## SUNDRY NOTICES AND REPORTS ON WELLS

WILLIAMS B FEDERAL #3

**LRE Operating, LLC**  
**Proposed 4 Stage San**  
**Andres Recompletion &**  
**Commingle With Yeso**  
**AFE # R13023**

**Williams B Federal 3  
30-015-34723  
LRE Operating, LLC.  
September 17, 2013  
Conditions of Approval**

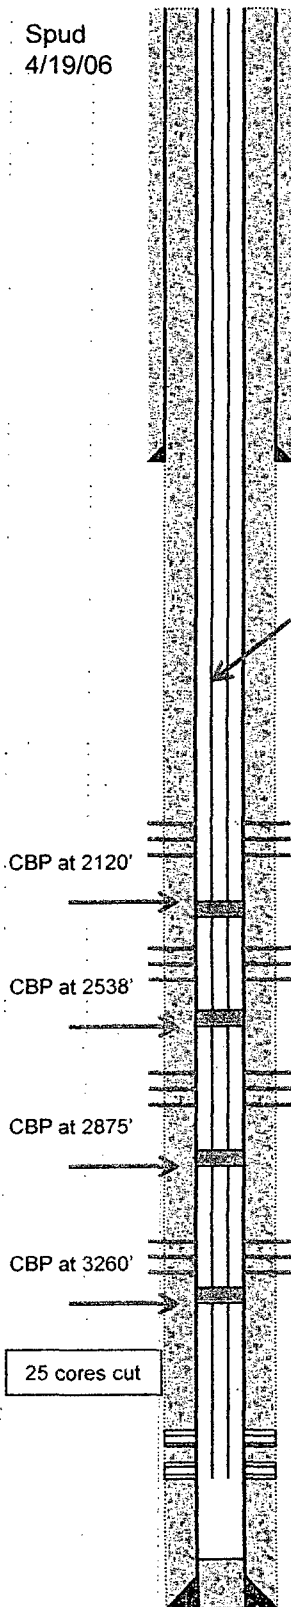
- 1. Must conduct a casing integrity test before any perforating or fracturing can be done. Submit results to BLM. The CIT is to be performed on the production casing to max treating pressure. Contact the BLM if test fails.**
- 2. No DHC shall be done without approval from both the BLM and the State.**
- 3. Operator is approved to drill out the CBPs at 2120', 2538', and 2875' and clean out the well to the CBP at 3260'. Put well on pump.**
- 4. Operator shall produce solely from the San Andres formation in order to establish a typical decline curve obtain reservoir data and submit results to the BLM for future DHC review.**

**NOTE: Sundry dated 09/09/2013 for DHC approval will be held until the above mentioned information is received and evaluated.**

9. A minimum of a 2000 (2M) BOP to be used. All blowout preventer (BOP) and related equipment (BOPE) shall comply with reasonable well control requirements. A two ram system with a blind ram and a pipe ram designed for the size of the work string shall be adequate. Tapered work strings will require an additional pipe ram. The manifold shall comply with Onshore Oil and Gas Order #2 Attachment I (2M Diagrams of Choke Manifold Equipment). The accumulator system shall have an immediately available power source to close the rams and retain 200 psi above pre-charge. The pre-charge test shall follow requirements in Onshore Order #2.
10. **Subsequent sundry required detailing work done and completion report for the new formation. Operator to include well bore schematic of current well condition when work is complete.**
